UNITED STATES PATENT AND TRADEMARK OFFICE

APPLICATION NO.	FILING DATE	FIRST NAMED INVENTOR	ATTORNEY DOCKET NO.	CONFIRMATION NO.
10/773,571	02/06/2004	Martin E. Thiede	1088.154US02	3554

Office Action Summary	Application No. 10/773,571	Applicant(s) THIEDE, MARTIN E.	
	Examiner Yvonne M. Horton	Art Unit 3635

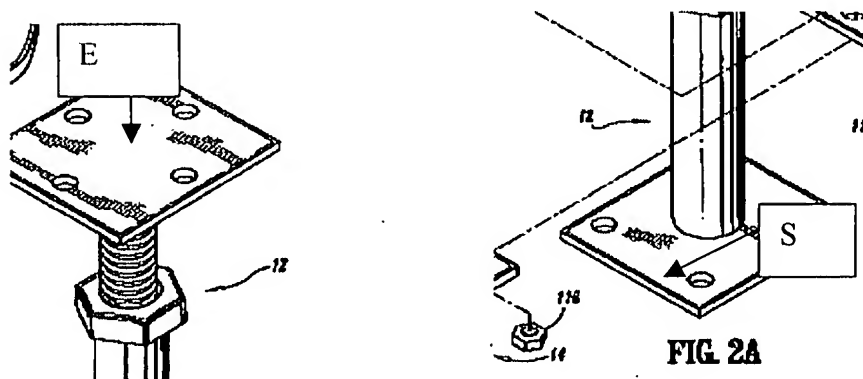
Claims 1,3-7,9,12, rejected under 35 U.S.C. 102(a) as being anticipated by US Patent #6,463,704 to JETTE. JETTE discloses a modular floor including at least two main beams (12) having an attachment structure including first and second sections (110,120) or (130,140) forming a channel (115) therebetween, at least one cross beam (CB) and floor panels (as at 10) that have a recess to receive (20) of beam (CB).

Regarding claims 3 and 9, bolts (48) and locking mechanism (52) are attached to the first and second ends of the main beam (12) by receipt of the bolt (48) within a recess (not labeled) formed in locking mechanism (52), see figure 2B. In reference to claims 5 and 6, the main beams include an extension (E) and a support (S) wherein the

extension (E) attaches to the attachment structure (110,120) Or (130,140). In reference to claim 7, the cross beams (CB) includes a main section (formed by 24,26,28) and ends (20).
